ADDENDUM NO. 2

**Three Rivers Community Schools – Three Rivers Middle School Additions and
Renovation**

SHEET CLARIFICATIONS / REVISIONS

1
M8.03 AIR COOLED CHILLER SYSTEM DIAGRAM
NOT TO SCALE

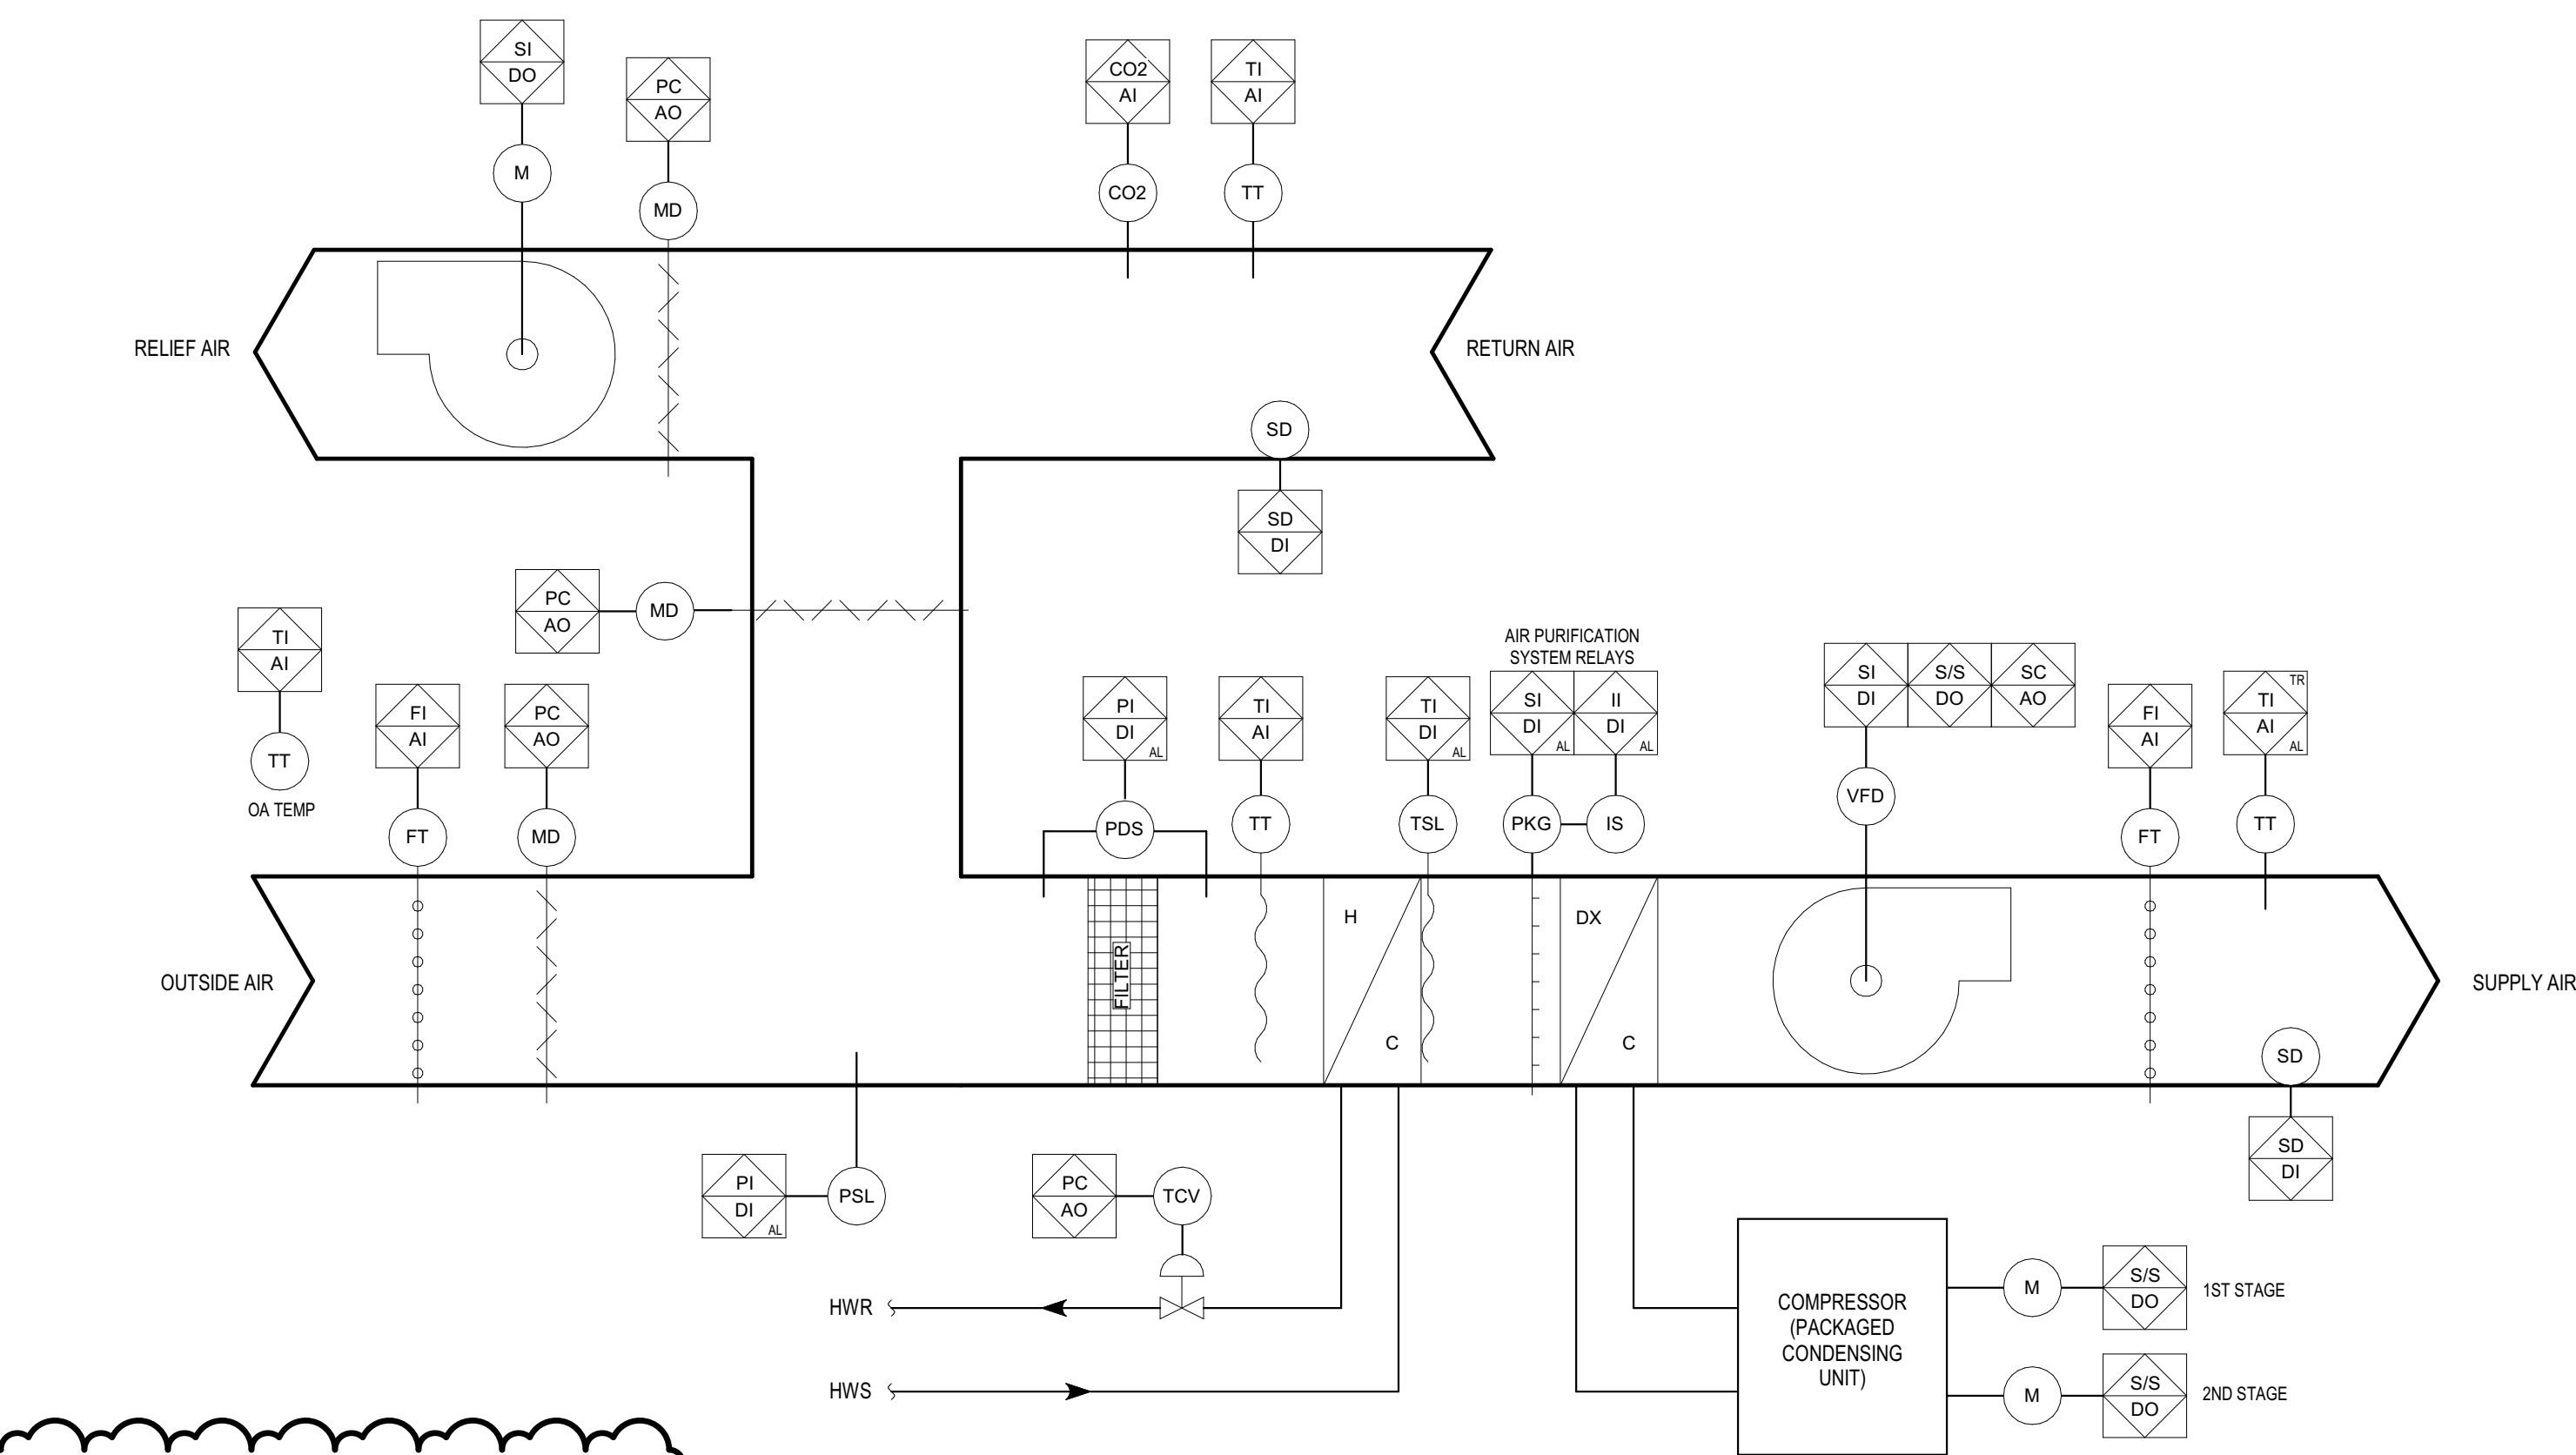
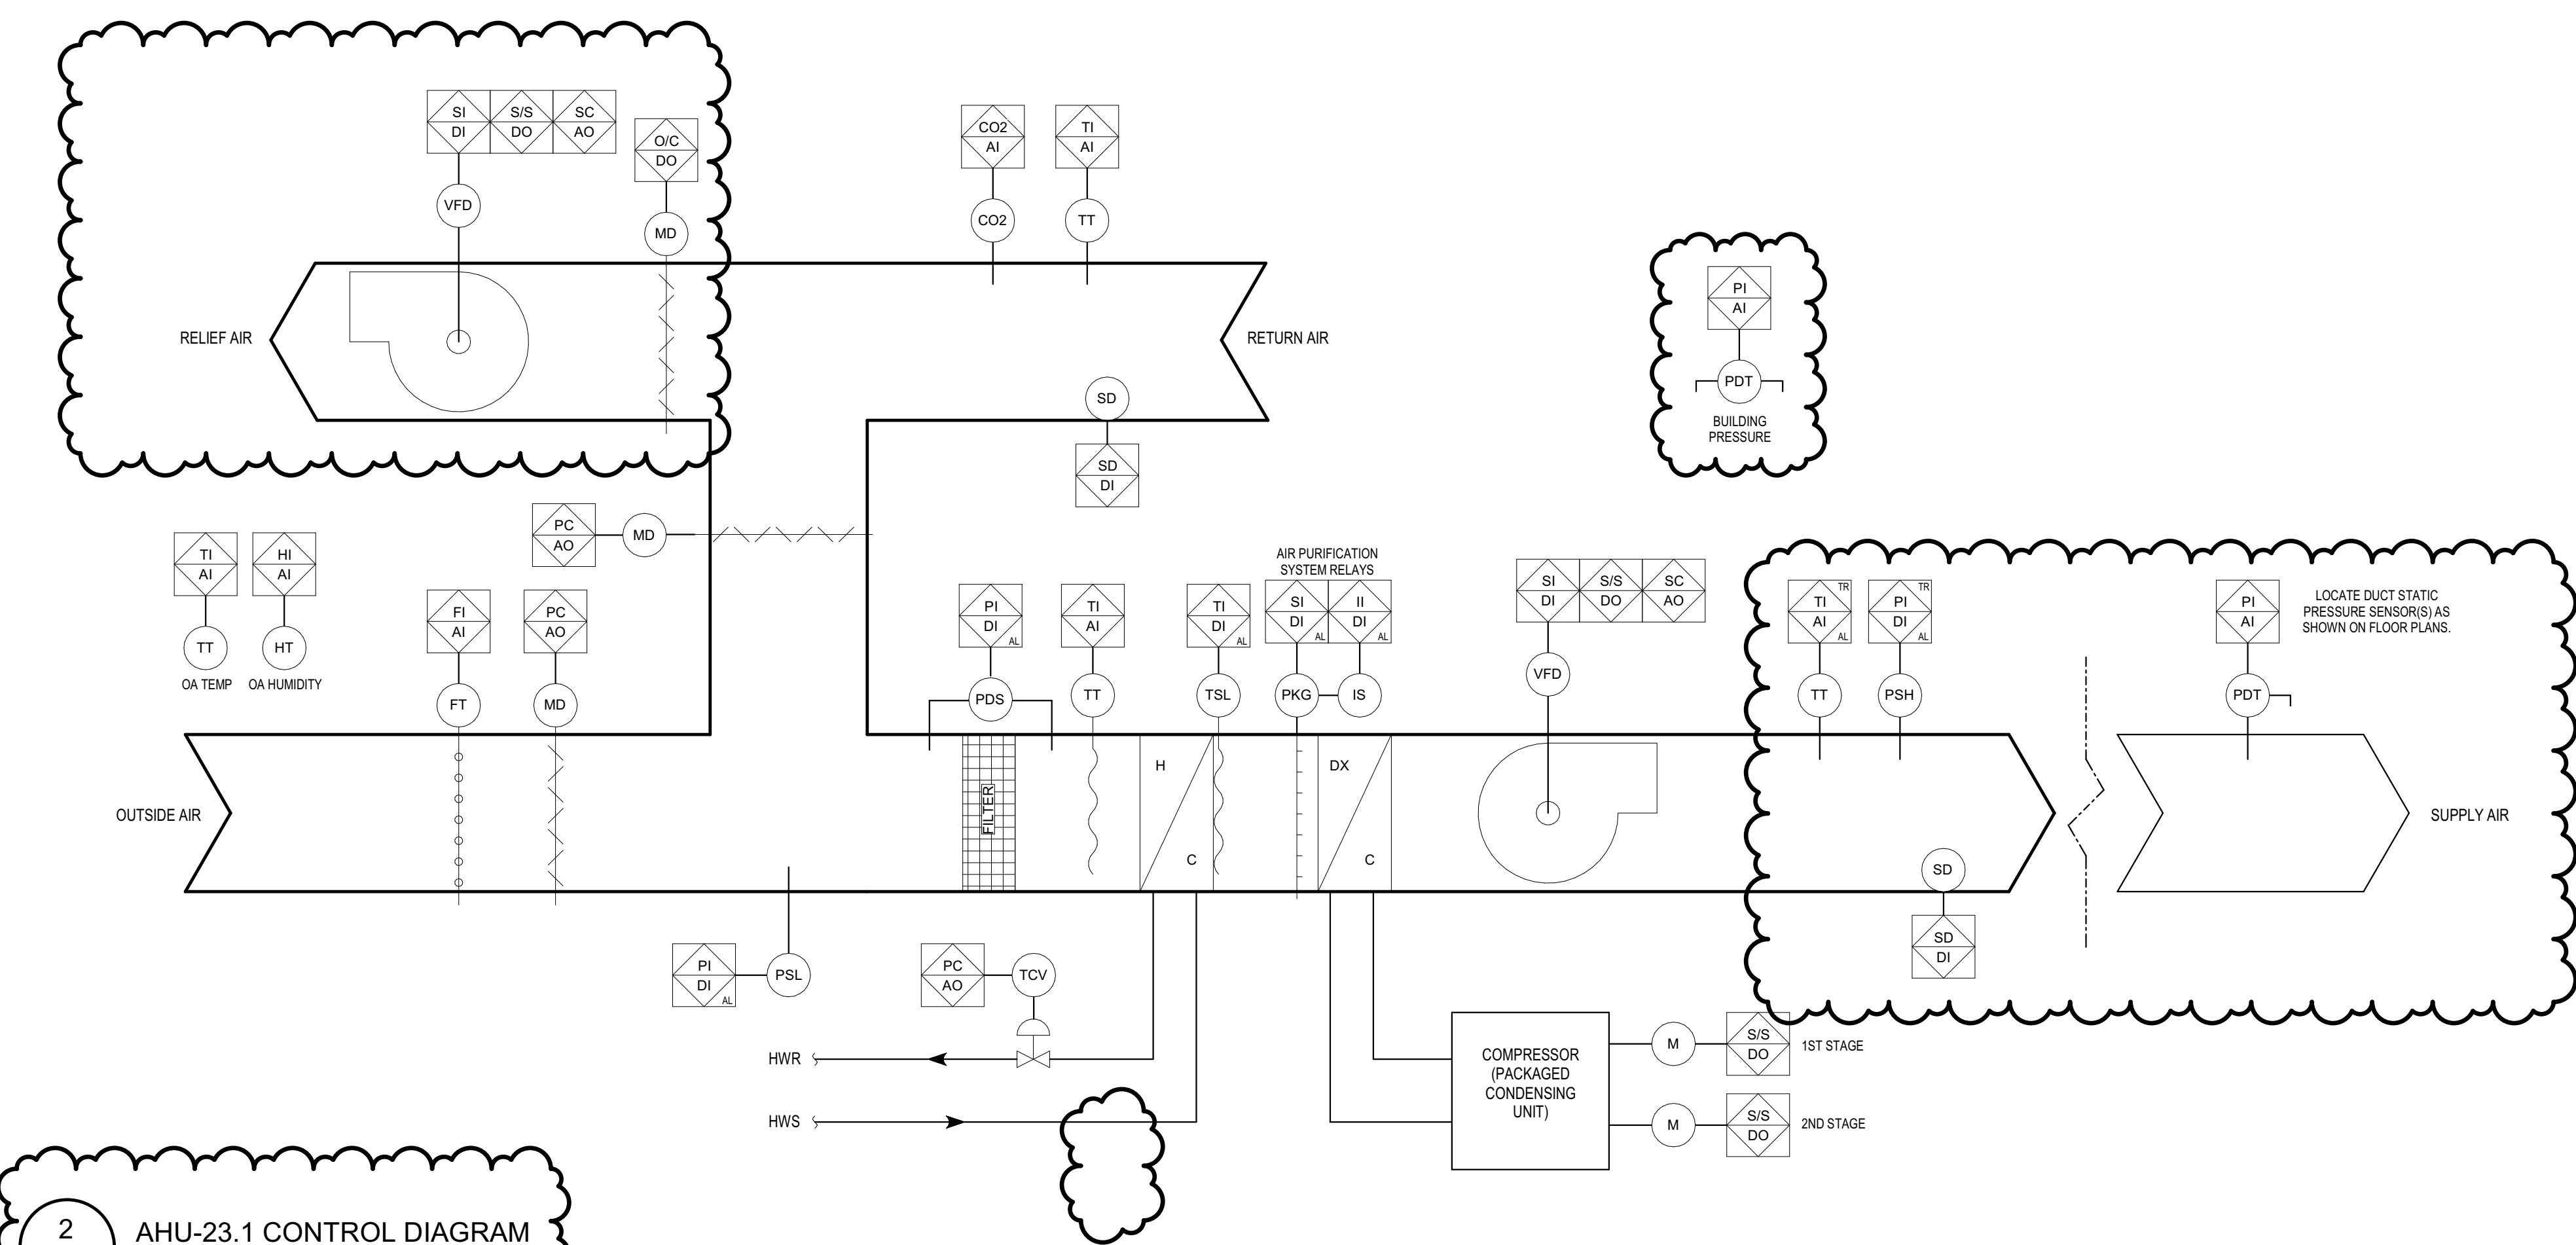
ITEM NO. 50 SHEET M8.03 MECHANICAL CONTROL DIAGRAMS (REISSUED)

Revised Mechanical Control Diagrams 2 and 3.
